SUPPLEMENT NO. 5

SAFETY EVALUATION REPORT

OFFICE OF NUCLEAR REACTOR REGULATION

DIABLO CANYON NUCLEAR POWER STATION, UNITS 1 AND 2

FIG. 1a PACOIMA DAM RESPONSE SPECTRUM 9 FEB 1971, S16E ,
2 PERCENT DAMPING, $\tau = 0, 0.04, 0.08, 0.12, 0.16$ sec.
COMPARED WITH DESIGN SPECTRA

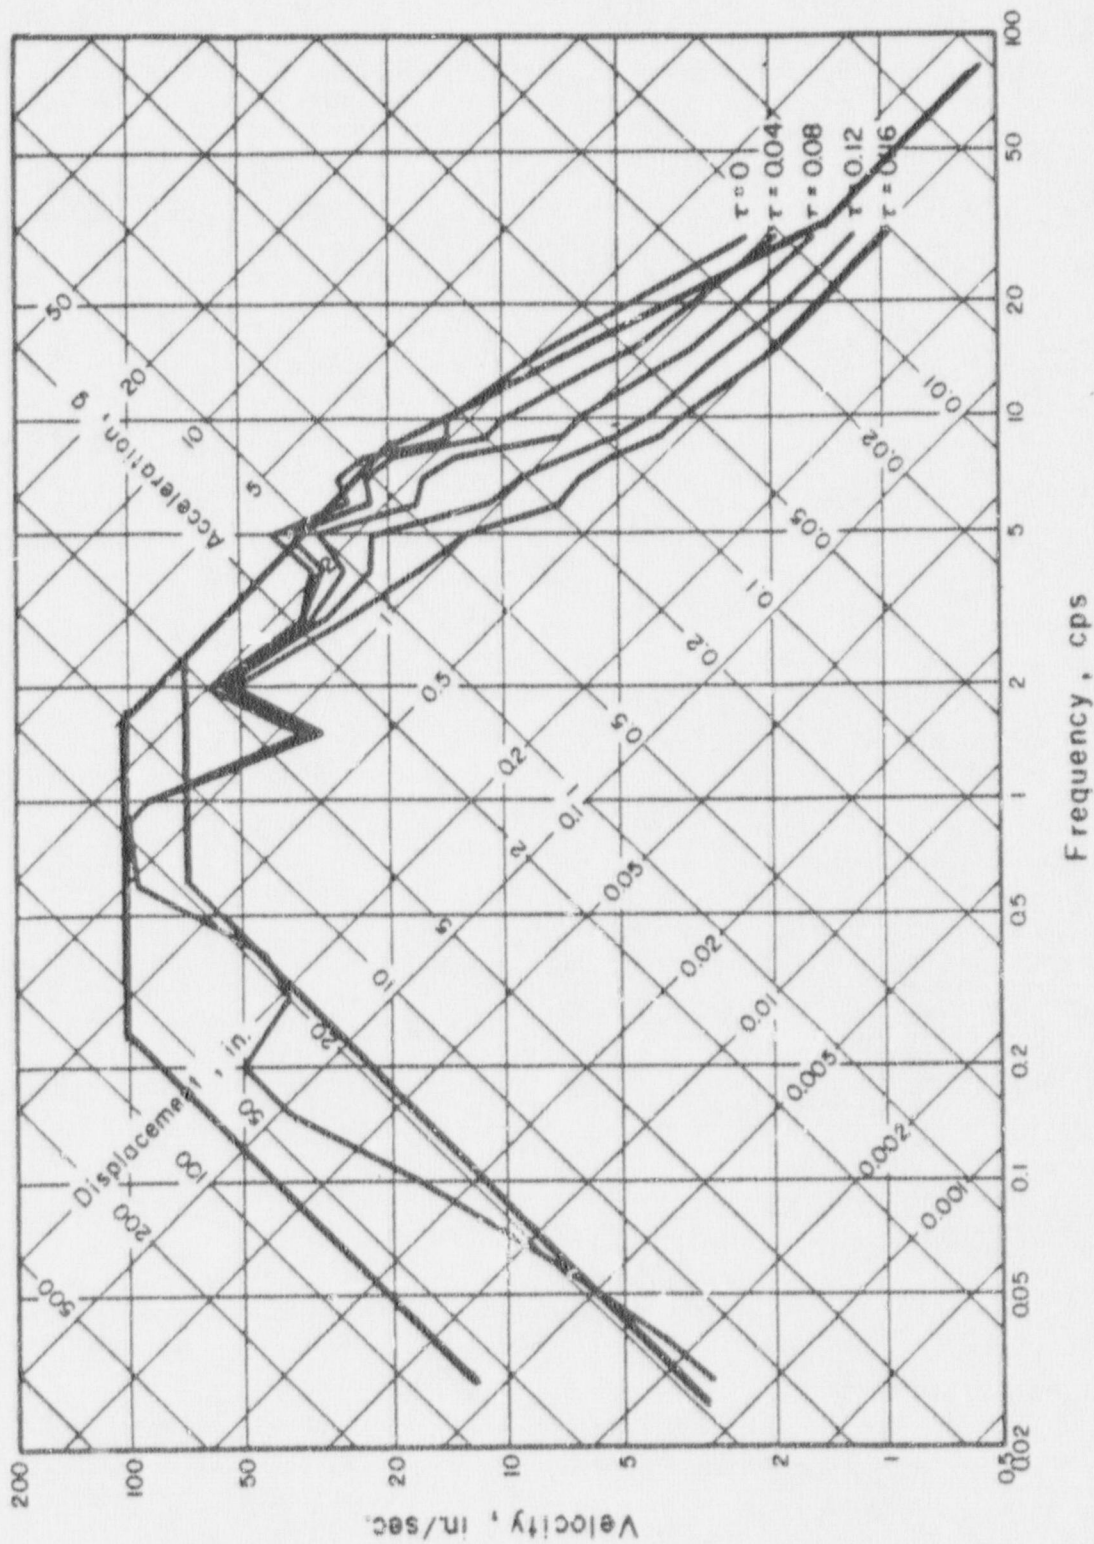
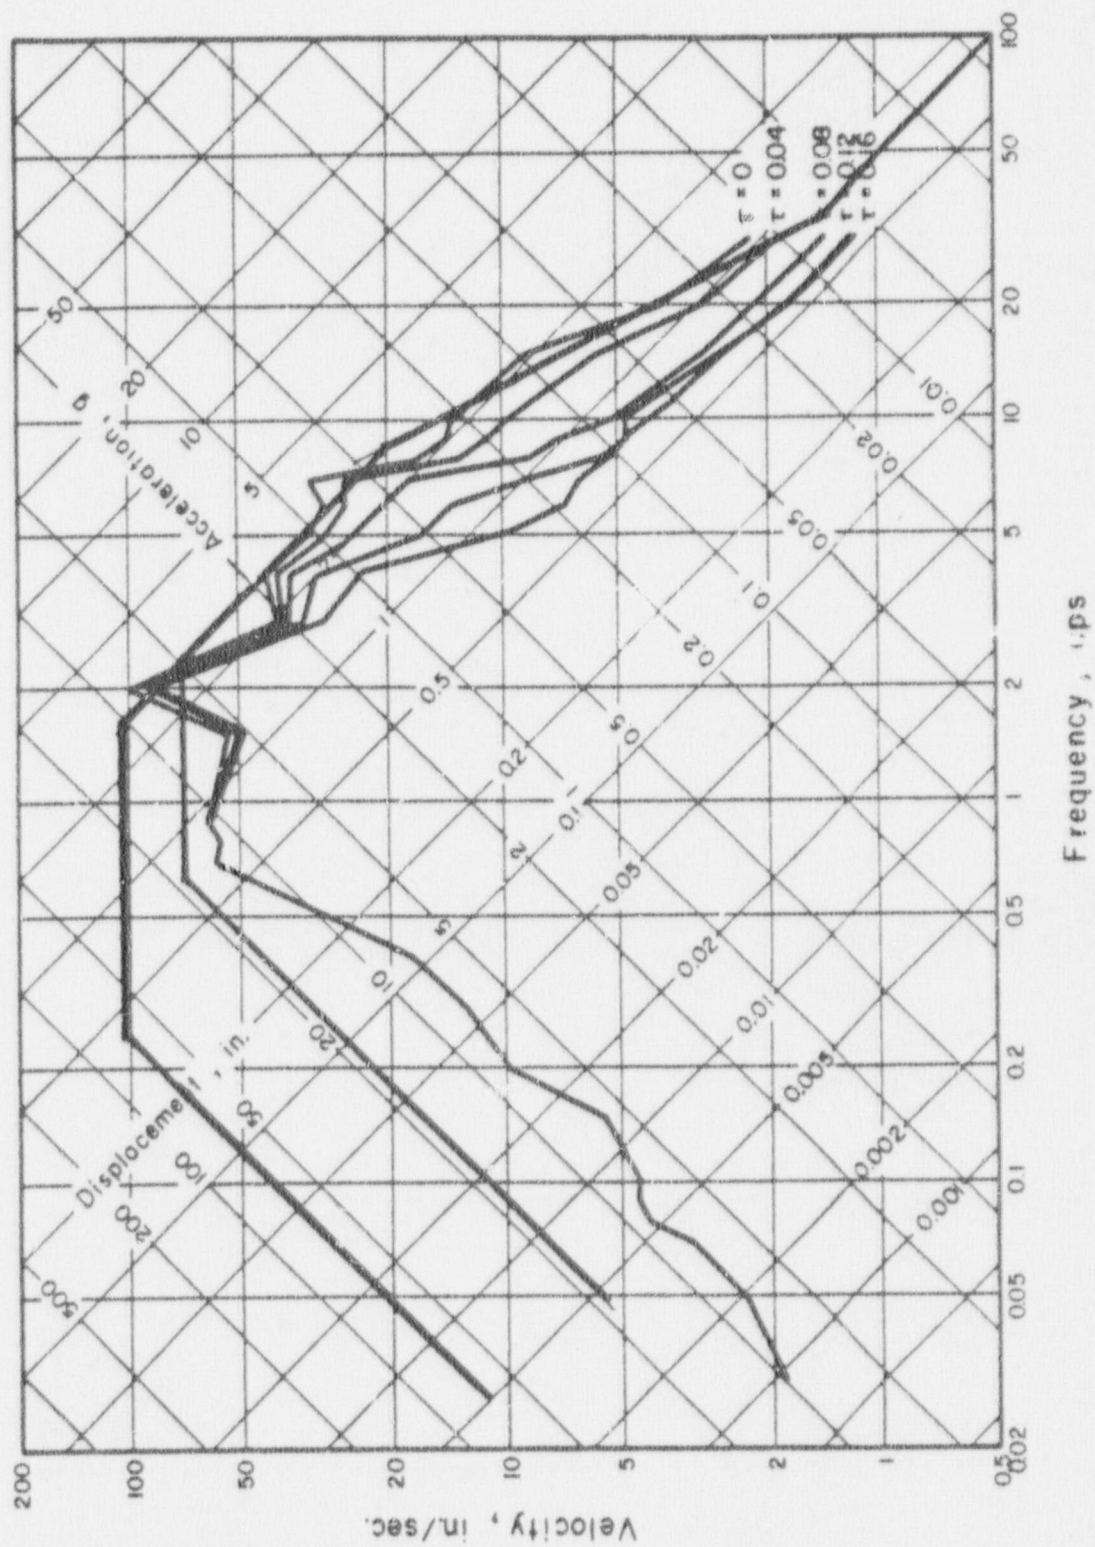
The most intense near field earthquake record available is that for Pacoima Dam in the San Fernando earthquake of 9 February 1971. For that record, there are shown in Figs. 1a and b comparisons of the response spectra, computed from the two horizontal records, with the design spectra developed in WASH-1255 (Ref. 4) and NUREG-0003 (Ref. 10). The computed response spectra for 2 percent damping are the upper curves in Fig. 1, identified by the symbol $\tau = 0$.

The design spectra for 2 percent damping, based on an effective acceleration of 0.75g, with the appropriate amplification factors (summarized below for convenience) are shown by the upper solid lines in Fig. 1. The standard velocity and displacement values used for drawing these are $0.75 \times 48 = 36$ in/sec, and $0.75 \times 36 = 27$ in., respectively. With amplification factors of 3.66 for acceleration, 2.92 for velocity, and 2.42 for displacement, for 2 percent damping, and one standard deviation above the median, the amplified values plotted are 2.75g, 105 in/sec, and 65 in. The plotted values generally envelope (with a substantial margin, on the whole) the computed spectra.

This is the most direct indication that the "effective" peak acceleration for the Pacoima Dam record is not in fact the measured value of 1.20g, but actually does not exceed 0.75g. Therefore this is taken as the effective peak acceleration for design.

FIG. 16 RECOMMENDED "DESIGN" SPECTRA FOR PLANT

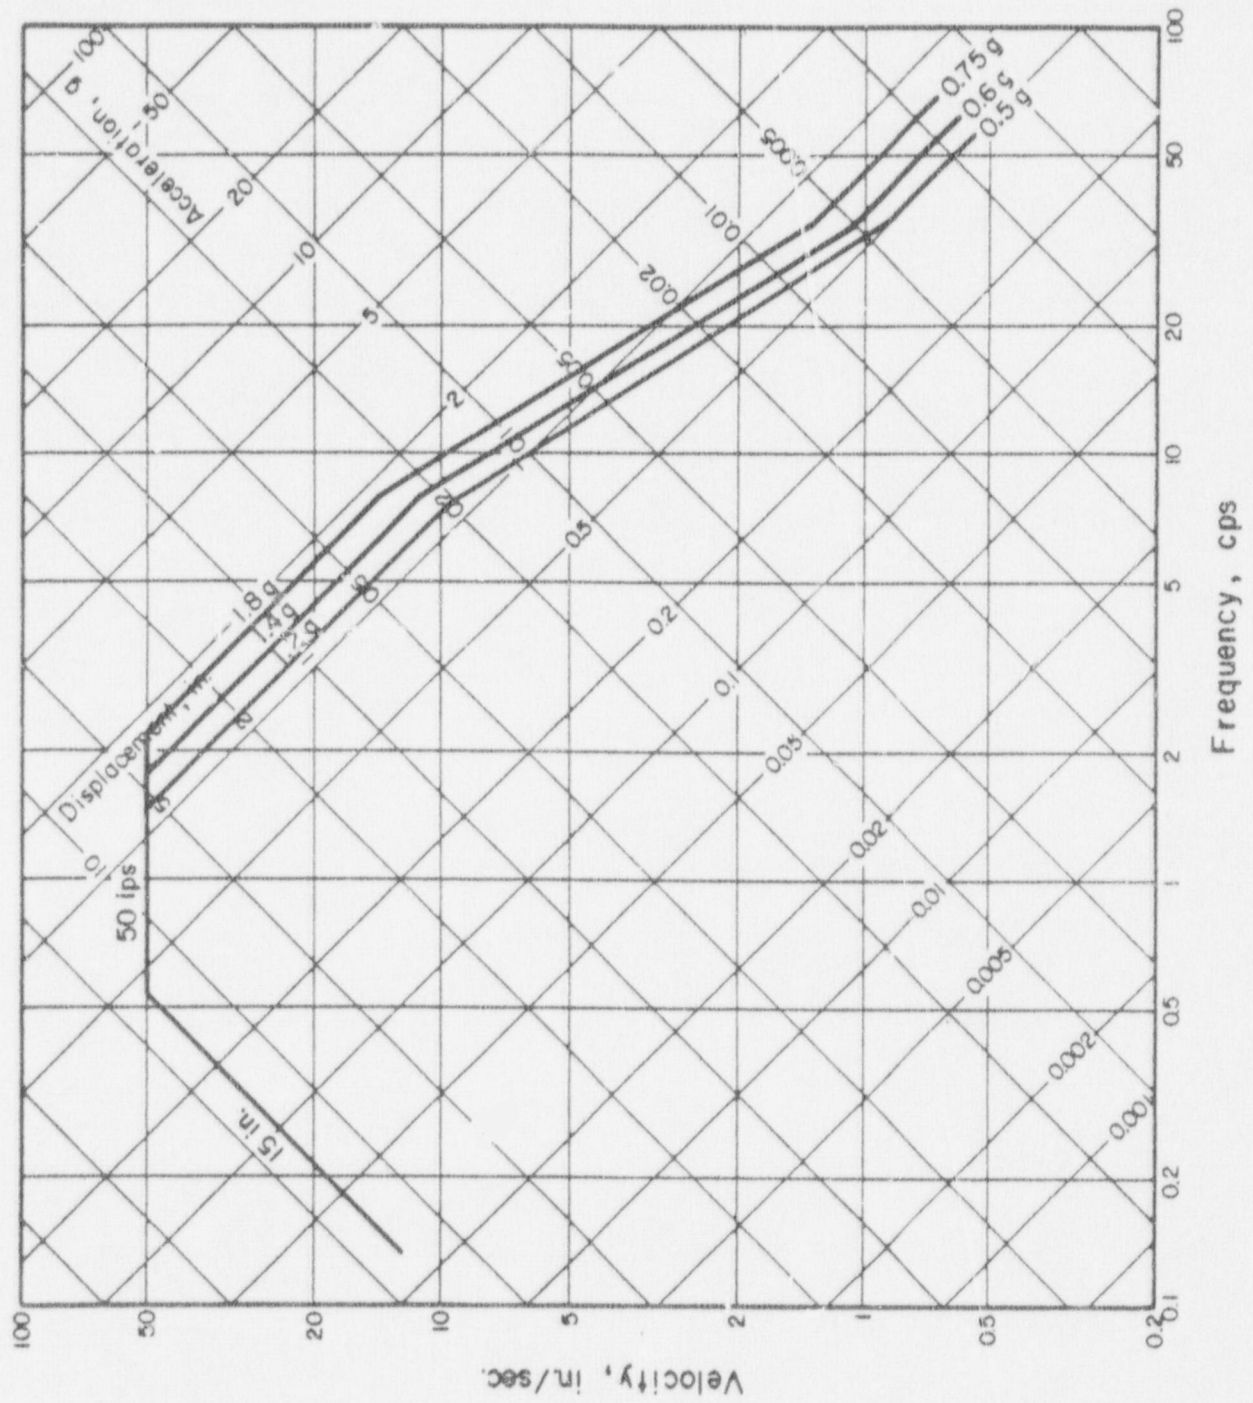
Referring again to Table 1, one finds spectrum bounds defined by the ground motions discussed earlier and the spectrum amplification factors given in Table 1, as shown on the last line of Table 1, for several acceleration levels. These values are plotted in Figs. 16 and 17 in terms of the usual type of design spectrum considered earlier in this report. The spectra shown in Fig. 16 are for the free field, for an acceleration level of 0.75g, the plant complex for an acceleration level of 0.6g, and for the reactor building for an acceleration level of 0.5g.

With the use of this relationship, ^{for} the reactor building, with its diameter of 160 ft and a wave velocity of 4000 fps, one finds a transit time of 0.04 sec, for which $R = 0.8$ and $A_f = 0.6g$. If one considers the entire plant structure as effectively tied together through the foundation, the effective width of about 480 ft gives a transit time of 0.12 sec, and the lower limit of $R = 0.67$ is applicable, with $A_f = 0.5g$. Small separate structures not close to the main complex should be designed for a higher spectrum, however, corresponding to the free field value of 0.75g.

FIG. 17 RECOMMENDED "DESIGN" SPECTRA, 7% DAMPING, COMPARED WITH "HOSGRI" AND DDE SPECTRA

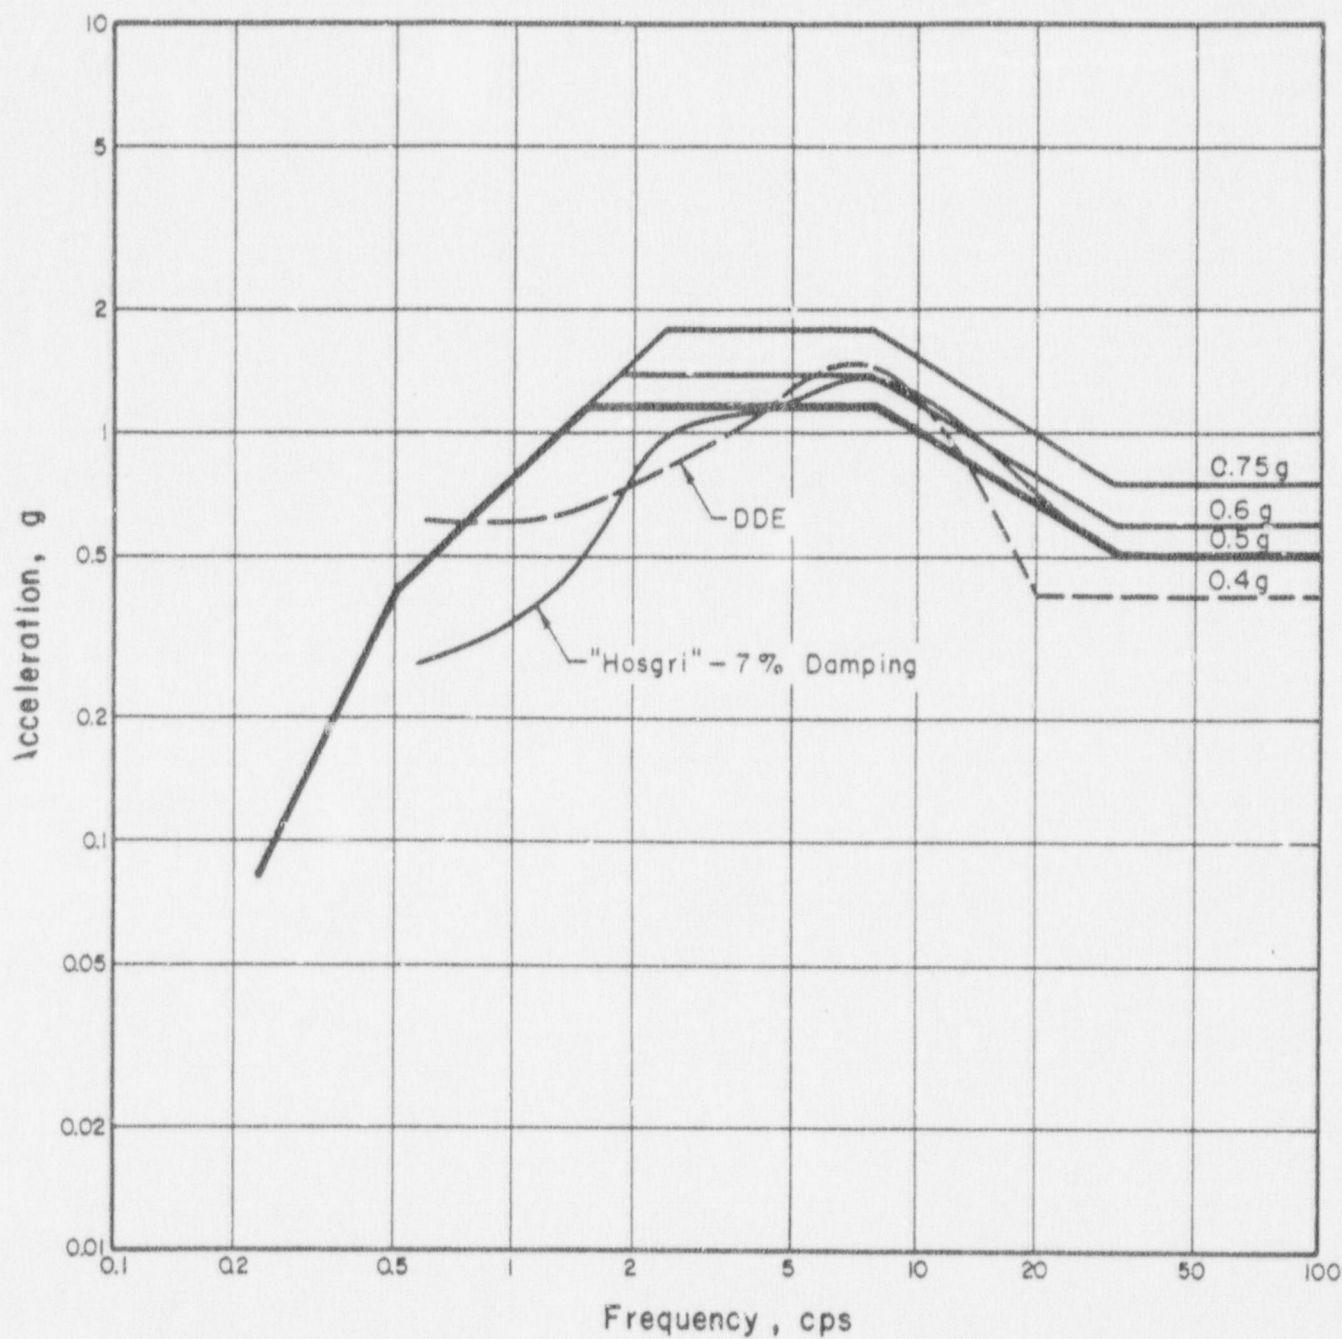
Figure 17 shows the spectra in Fig. 16 plotted in another way, in terms of acceleration values as a function of frequency, and compared with previously used design spectra for the plant. These previously used values are defined as the DDE or the double design earthquake spectrum originally used of 0.4g maximum ground acceleration, and the so-called "Hosgri" spectrum which has been developed by Dr. John A. Blume for PG&E. It appears that the latter is relatively close to the recommended design spectrum for 0.5g developed herein for frequencies higher than about 2 or 3 hertz, but may be somewhat low for lower frequency elements.
